कार्यालय अधिशासी अभियन्ता,
निर्माण खण्ड, लोक निर्माण विभाग, रानीखेत

दूरभाष :- 05966-220035 फैक्स :- 05966-220035 ई-मेल cdpwdrkt@gmail.com
पत्रांक 1437 / 18सी. दिनांक, रानीखेत, 18-6-2016

विषय :- कुनीगाड हिरुली बाजार से रामपुर चौखुटिया मोटर मार्ग के वन भूमि हस्तान्तरण के सम्बन्ध में। (प्रस्ताव सं. 8986/2014)

कार्य का नाम :- कुनीगाड हिरुली बाजार मोटर मार्ग का रामपुर चौखुटिया तक विस्तार मोटर मार्ग का निर्माण

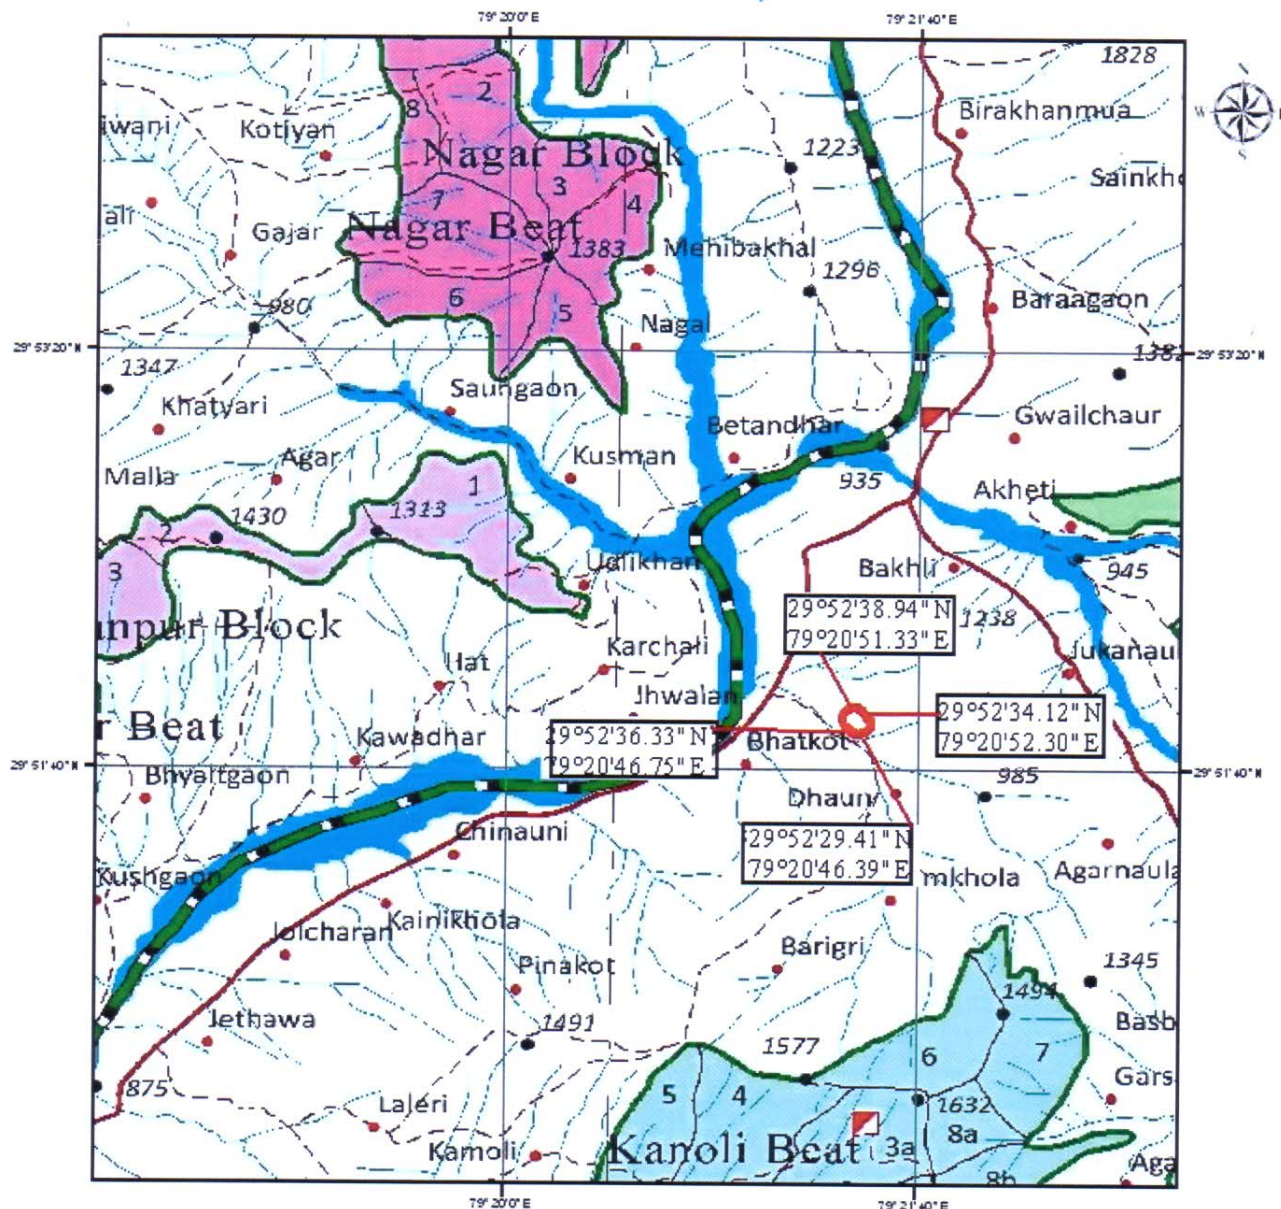
1	Digital map not proper as coordinates are written in hand. Proper digital map may provided.	Proper digital map with computerized coordinates is being attached .
2	In the map end point is shown for away from Rampur.	.The Rampur Village is on the right side of the National Highway (shown as red colour) in the digital map. The portion of the road from the end point of the proposed road upto the National Highway near Rampur has already been constructed which is shown as black colour in digital map. The revised digital map is being attached as in point no.-1
3	No titles given to thee document provided in the list of additional documents in part I.	Titles given to the documents has been incorporated in the list of additional documents in part-1
4	Forest land proposed for diversion shown as Van panchayat land in joint inspection report whereas shown PF in part II	
5	In Ca land map coordinates are provided for one point only whereas CA land being more than 1 ha coordinates at minimum 4 points are required.	Digital map for C.A. consisting coordinates of 4 points is being attached.
